Conductor Bar in EMS-Systems Program 0811

Contents

1.3 Replace copper-graphite Collectors with pure graphite Collectors

Fig. 4: Replace copper-graphite Collectors with pure graphite Collectors

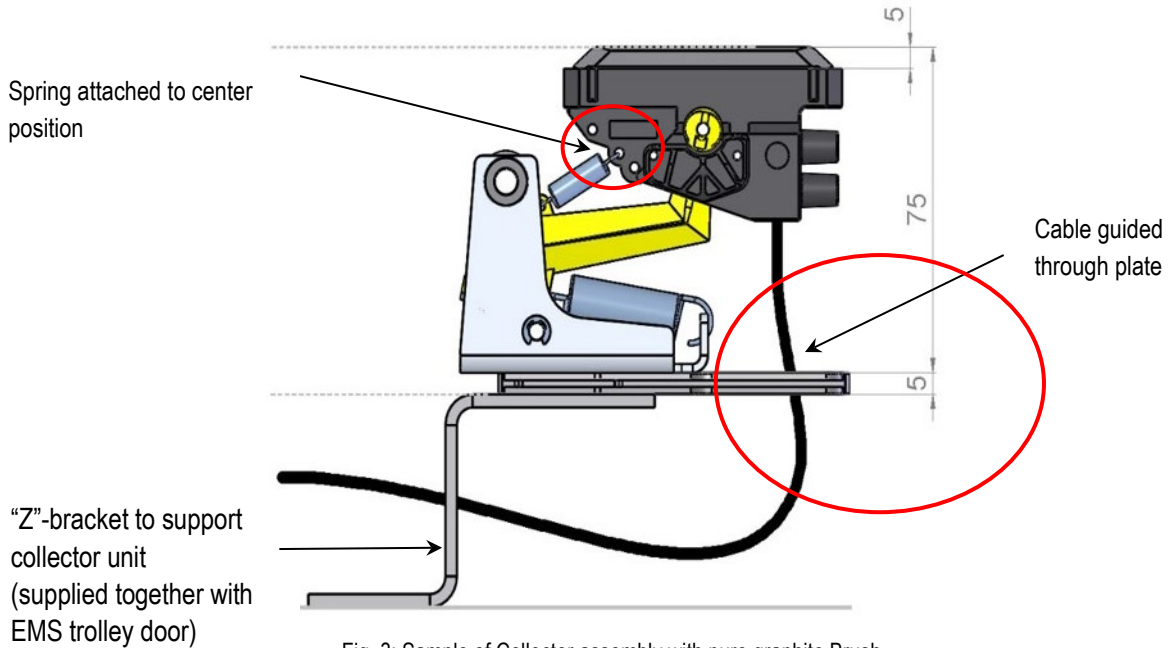
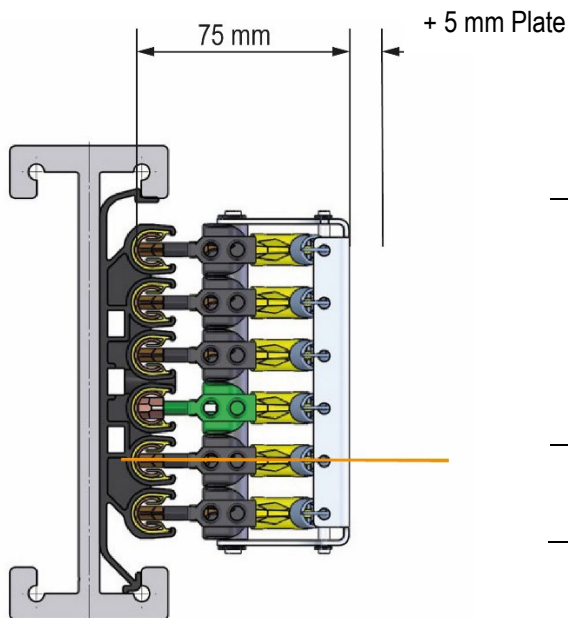
1. Old copper- graphite collector height (when engaged): 80 mm (due to brush head with 10 mm height).
New pure graphite collector height (when engaged): 75 mm (due to brush head with 5 mm height)
Plate 5 mm must be used
2. Collector adjustment: Exact center line of copper rail and brush head to be kept

BMW stipulates a plate with a cable guide 08-P025-0191-001. This plate must be considered for new installations and rebuilding. It allows the obeying of the correct installation dimensions and a safe cable guide.
For EMS applications which are not used for BMW we also recommend to retrofit the plate according to the distance dimension of 75 mm.

Fig. 5: Cables which are not installed correctly

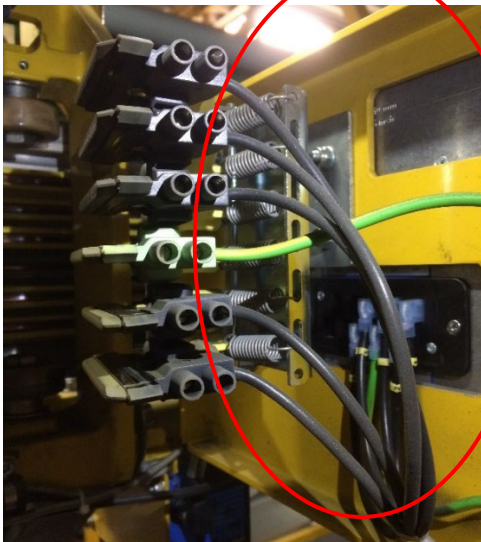
1. Cables are not installed correctly:
 - No parallel cable guide
 - Cable bundle creates force on collector heads
 - Collector heads are not running parallel to conductor rail

Fig. 6: Collector adjustment

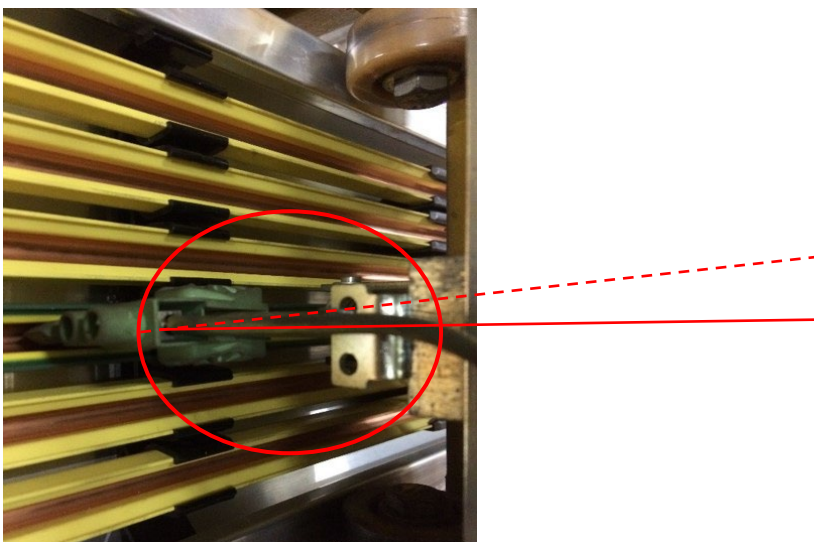
2. Collector adjustment: Brush head not aligned properly (too high!) = Brush head runs permanently in an angle and grinds the plastic isolation of the conductor rail.
